# Thursday, July 11, 2024 at 6:00 p.m. Section 28 Hearing Re: 10 Lakeside Drive, Stoney Creek Permit Application No. SC/F,C,A/24/40

# **Hearing Report**

Authorities Act for an Application by Sayed Shakour for Development in a Regulated Area of Lake Ontario at 10 Lakeside Drive, City of Hamilton (Stoney Creek) – Permit

Application No. SC/F,C,A/24/40

Figure 3. Erosion hazard associated with Lake Ontario. The 10.00 m erosion allowance presumes a recession rate of 0.2 m/yr.

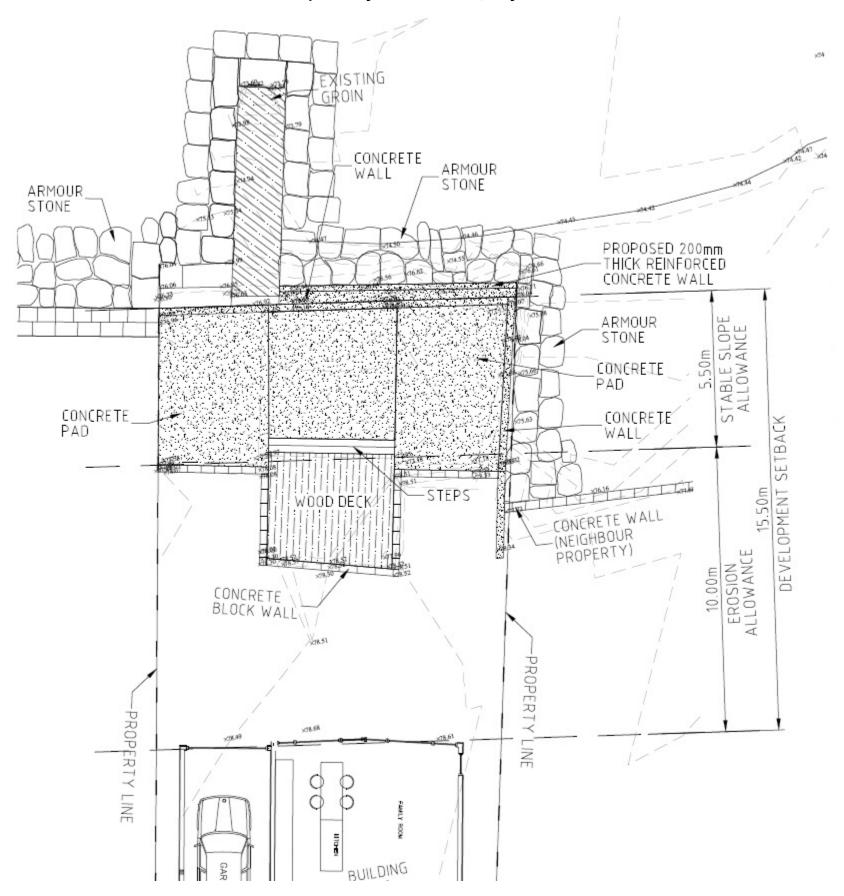
Concerns remain regarding the hazard setbacks related to the proposed second storey addition. Information provided in the HCA's new (draft) Shoreline Management Plan suggests that a recession rate of 0.3 m/yr may not be sufficiently conservative. In addition, the shorewall plans propose a tie-in to the existing shorewall at 8 Lakeside Dr, but if the shorewall on the adjacent property becomes damaged, there is still the potential for erosion from the flank. As described above, existing access to the property is constrained. Although there is no change to access relative to the existing conditions, future maintenance and construction on the shore will be a challenge.

Figure 4. Proposed site plan.

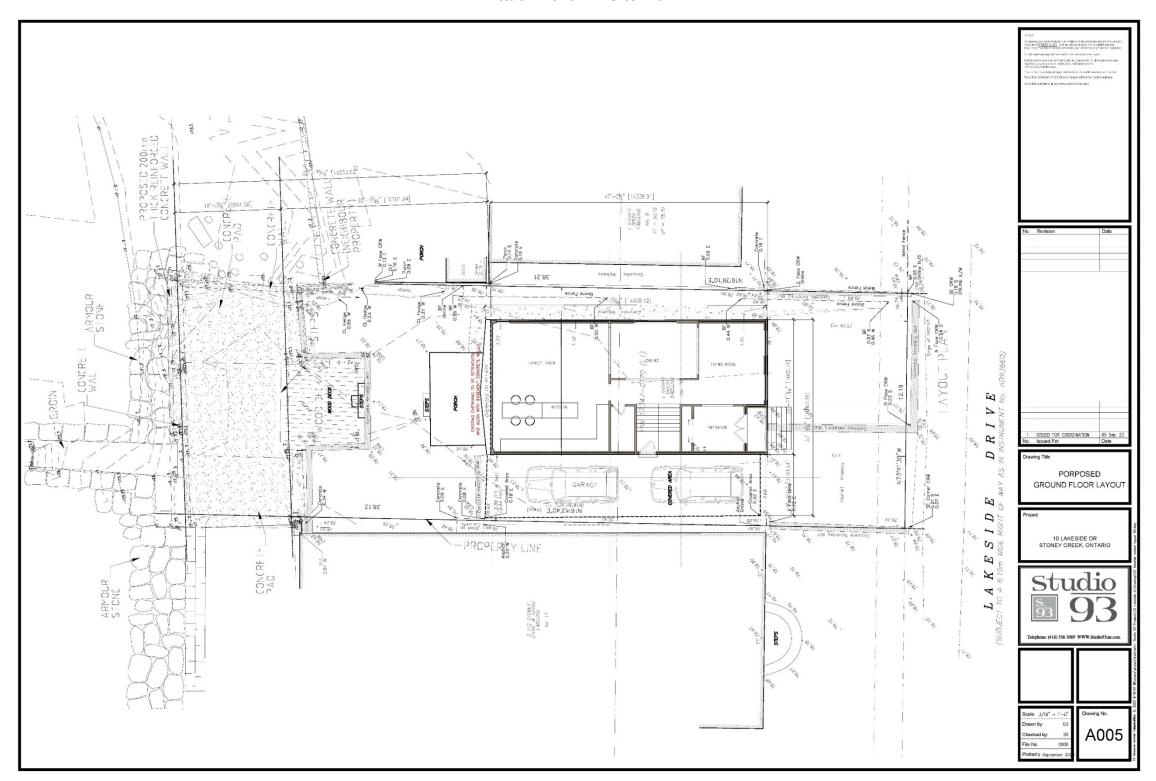
The subject application proposes development within the erosion hazard associated with Lake Ontario, and provides less side yard access than HCA policy recommends. Provincial and HCA policies take a preventative approach to addressing the potential risks and impacts associated with natural hazards by generally directing development to areas outside of hazardous lands. It is HCA staff's opinion the policy framework outlined in HCA's *Planning and Regulation Policies and Guidelines (October, 2011)* does not support the proposed development.

Figure 12. Proposed shorewall design.

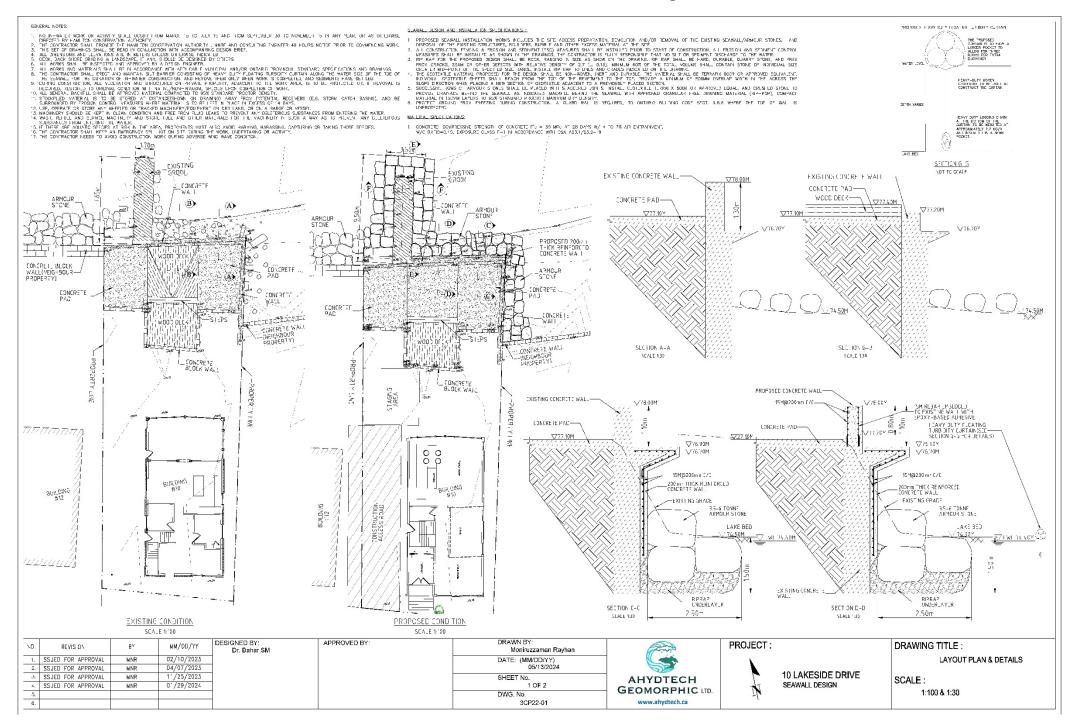
In September, 2023, a revised report was submitted. HCA responded in October, 2023, identifying several concerns with the proposal. The coastal assessment identified that the height of the wall could be reduced from 78.5 m to 78 m, because the presence of the groyne would reduce wave uprush. HCA responded that this plan should be approved by MNRF, and if MNRF was not supportive of reinforcing the groyne that the shorewall should be designed to protect the rear yard from flooding at an elevation of 78.5 m. In addition, HCA requested that construction access be confirmed. HCA requested that information be provided to address the potential for flank erosion from

In April, 2024, HCA received a copy of the authorization from MNRF for the work to the shorewall, including the reinforcement of the existing groyne. HCA staff reviewed the information provided, and advised that the reinforcement of the groyne should be rested below the scour depth to prevent the armoring from becoming undermined.

In May, 2024, revised drawings were submitted, and HCA staff advised that our technical comments relating to the shore protection had been satisfied. Staff further advised that the proposed development was within the shoreline hazard, and as such the application would not be supported by HCA policy. The applicant requested to have the proposal reviewed at a Hearing in front of the HCA Board of Directors, and accordingly submitted a completed permit application form and a final proposed site plan on June 9, 2024.

Layout Plan and Section Details of Erosion Hazard Limit/Development Setback at 10 Lakeside Drive Property (Annex – V, Sheet 2)

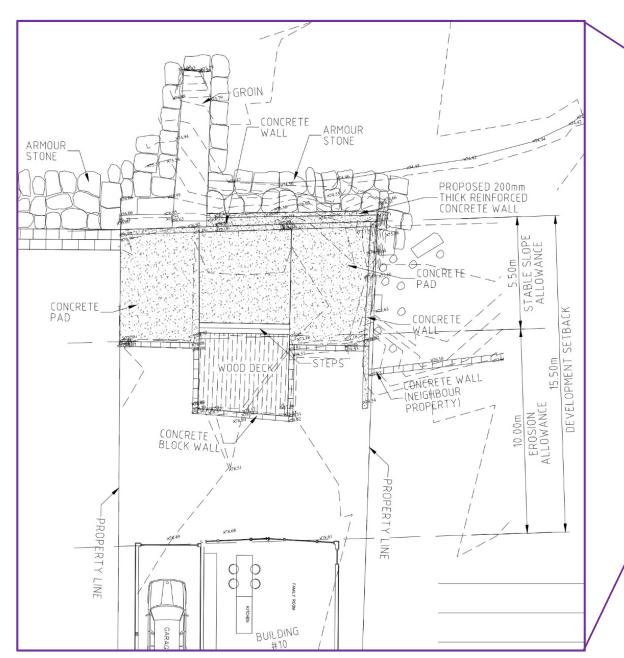
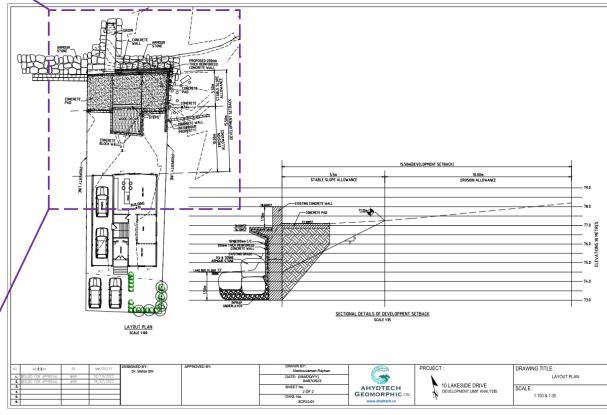
In addition, the shorewall plans propose a tie-in to the existing shorewall at 8 Lakeside Dr, but if the shorewall on the adjacent property becomes damaged, there is still the potential for erosion from the flank.

AHYDTECH agreed with ensuring the most conservative assessment and applied recession rate of 0.2m/yr while delineating the erosion hazard limit for the property site. The Technical Report and Layout Plan Drawing have been updated accordingly.
